#### Report to the Future Melbourne (Planning) Committee

Planning Permit Application: TP-2015-942 17-19 Gipps Street, East Melbourne

#### DELEGATED PLANNING APPLICATION REPORT

**Proposal:** Partial demolition and alterations and

TP202 4

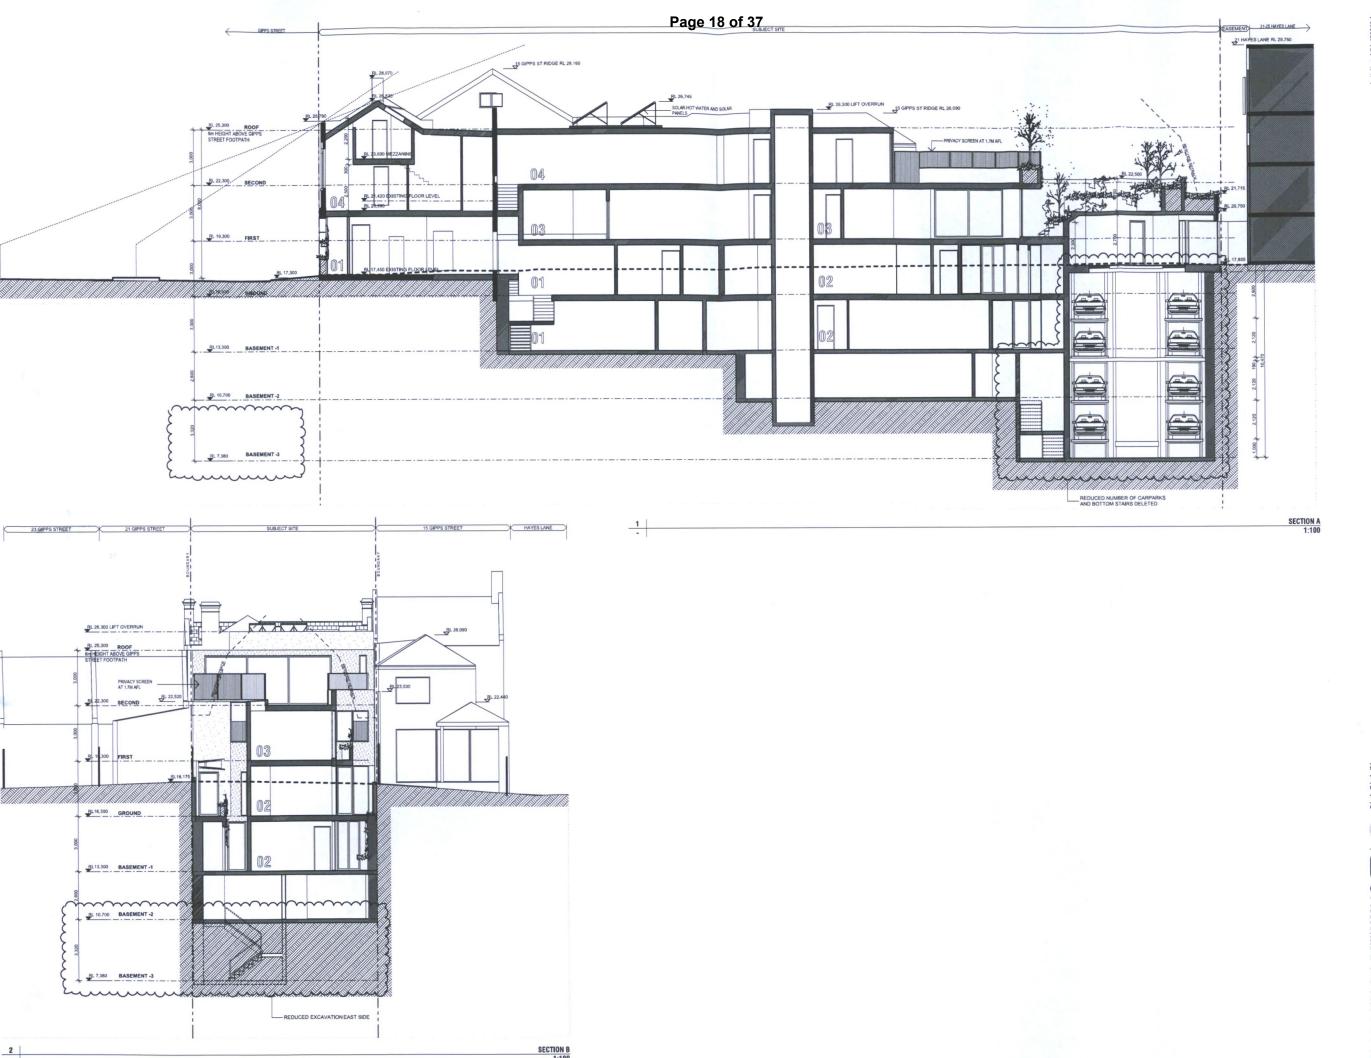
additions complies with the performance standard which requires partial concealment in a level 2 streetscape. This is evident in the sightline on revised plan TP202 dated 12 February 2016.
